AL KASIK LOCATION COMMAND
AL KASIK, IRAQ

SIGIR PA-09-182
OCTOBER 16, 2009

Summary of Report: PA-09-182

Figure 8. Schematic of pallet rack configuration and layout (Courtesy of USACE)

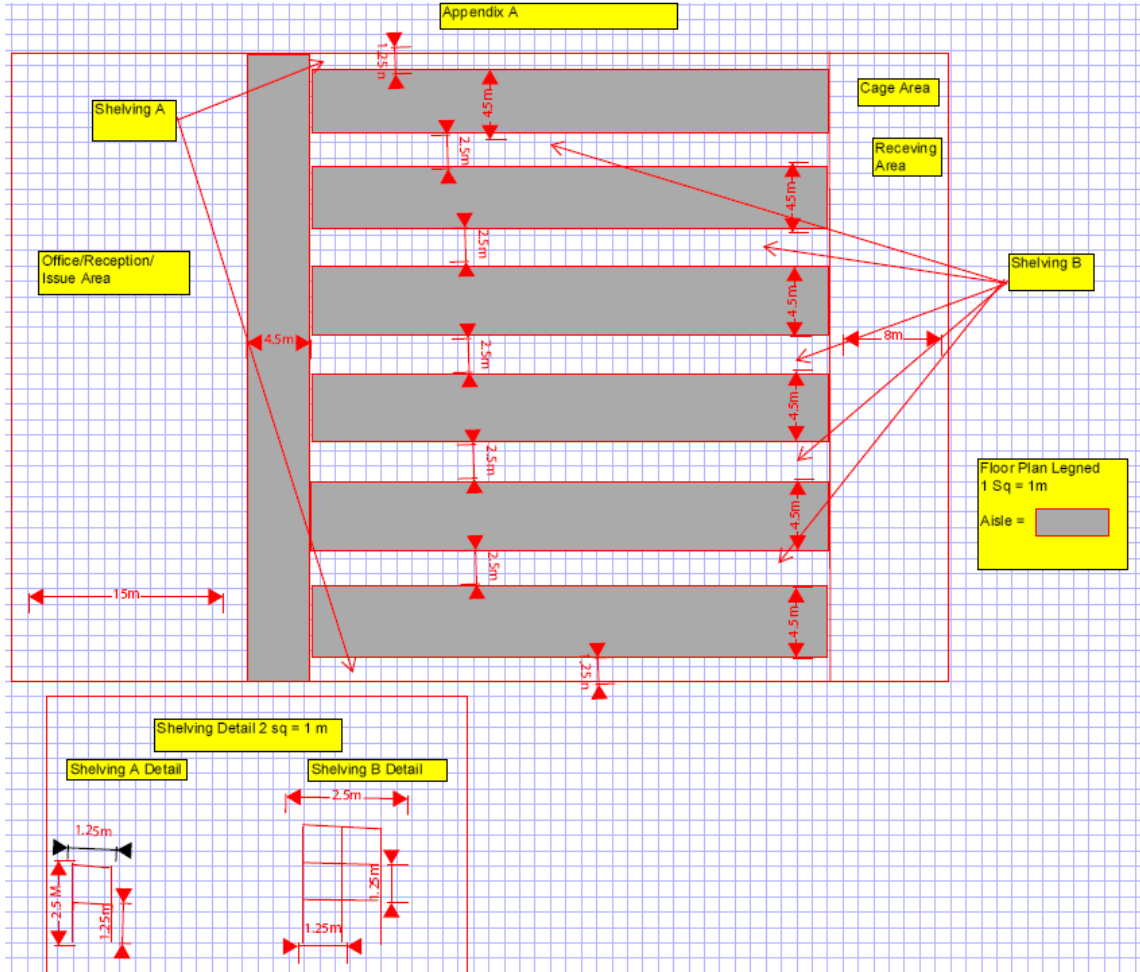
The SOW did not specify the size of the base plate for the rack legs. The dimensions of the base plate are critical in determining the allowable capacity of the concrete floor slab. To prevent cracking and failure of the slab, the base plate sizes should be specified based on the thickness of the existing slab. The information provided by GRN did not include any submittals for the pallet rack system.

Site Photo 11. Site grading for diesel storage at the distribution point

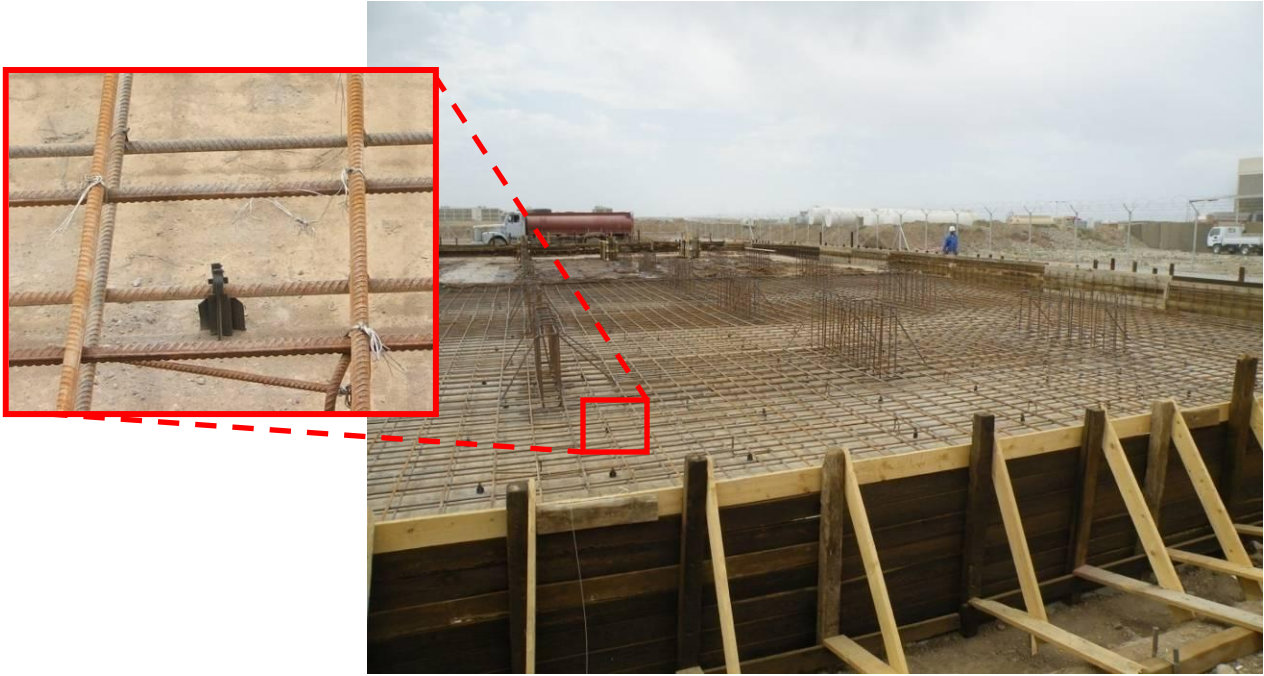
During the inspection of the raft foundation, SIGIR discovered one issue. It appeared that the contractor placed a construction joint near the middle of the foundation slab. It did not appear that provisions were made to continue the reinforcing steel through the construction joint or provide fuel proofing. There was also no evidence of a shear transfer mechanism at the joint—such as dowels or a shear key—and no fuel stop was noted.

The GRN Mosul Area Office personnel stated that the contractor would perform a final check of the rack system after construction completion to verify that all bracing is installed and that all legs are securely fastened to the floor slab. The other issues would be addressed throughout the project, and corrective action would be taken as necessary.
